# RIVERSIDE STATION APARTMENTS

RECEIVED  
 05/03/2022  
 CITY OF MONROE

SPR2022-01  
 #8571

COVER SHEET AND PROJECT OVERVIEW  
 PROJECT NO: 2021-126  
 DATE: DECEMBER 28, 2021

SHEET C-15  
15 OF 16

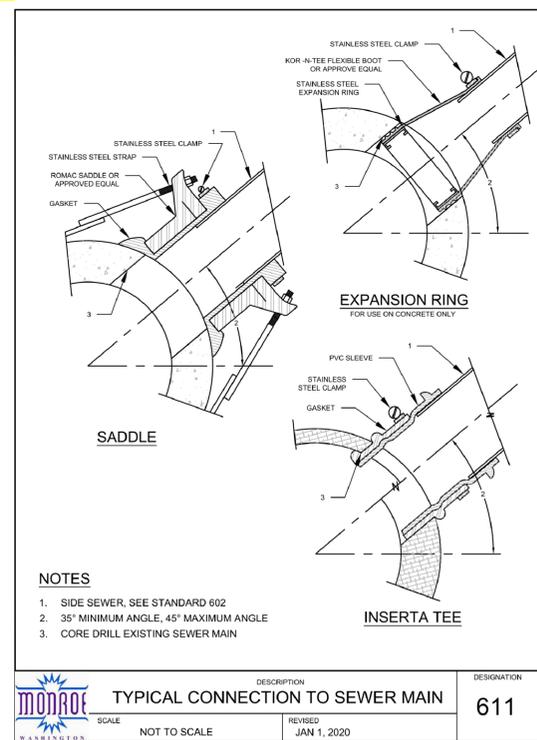
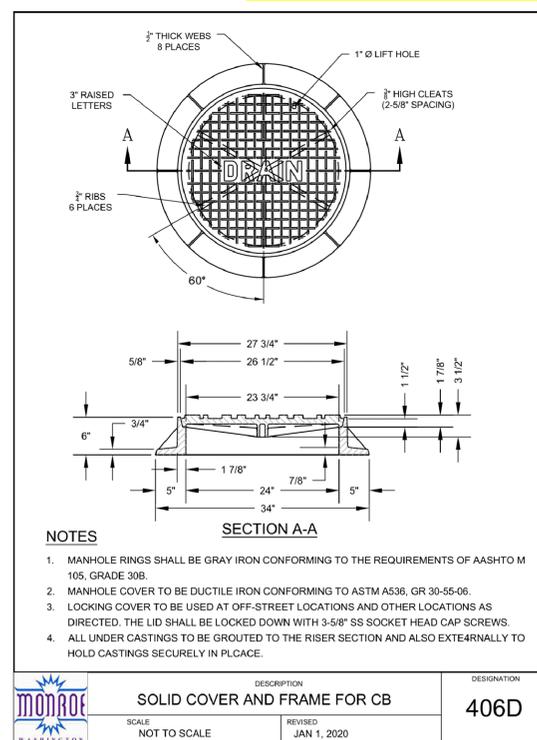
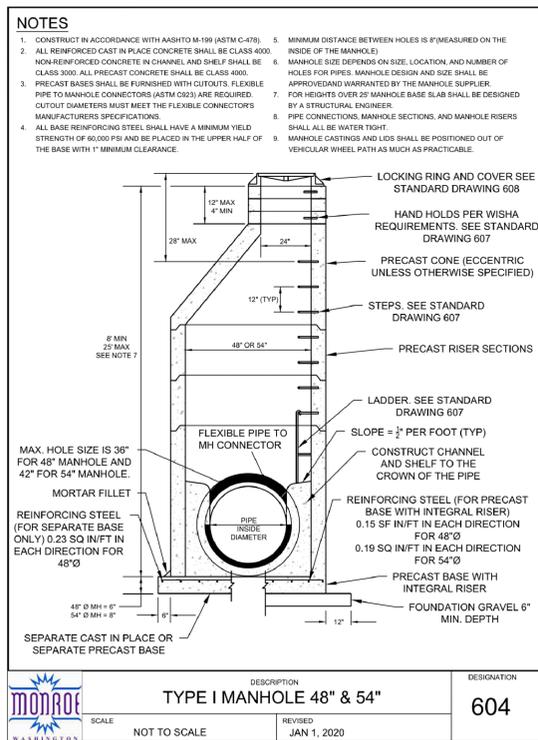
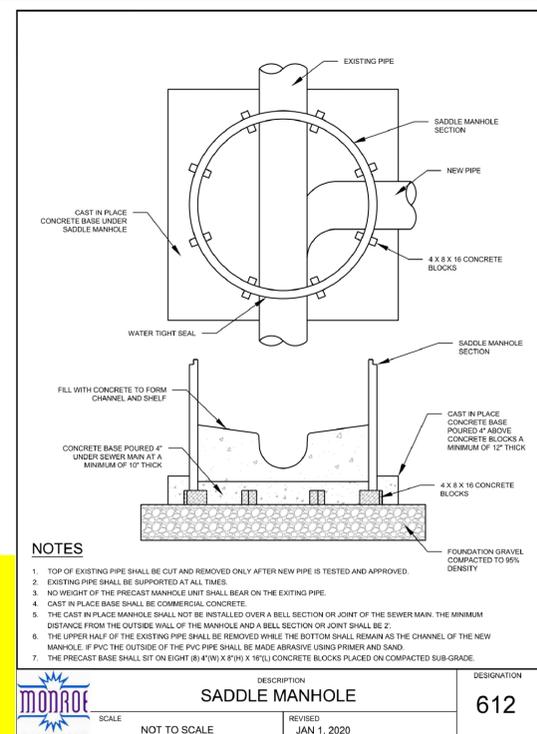
Update all standard details to the latest version. Available on-line at: <https://www.monroewa.gov/standards>
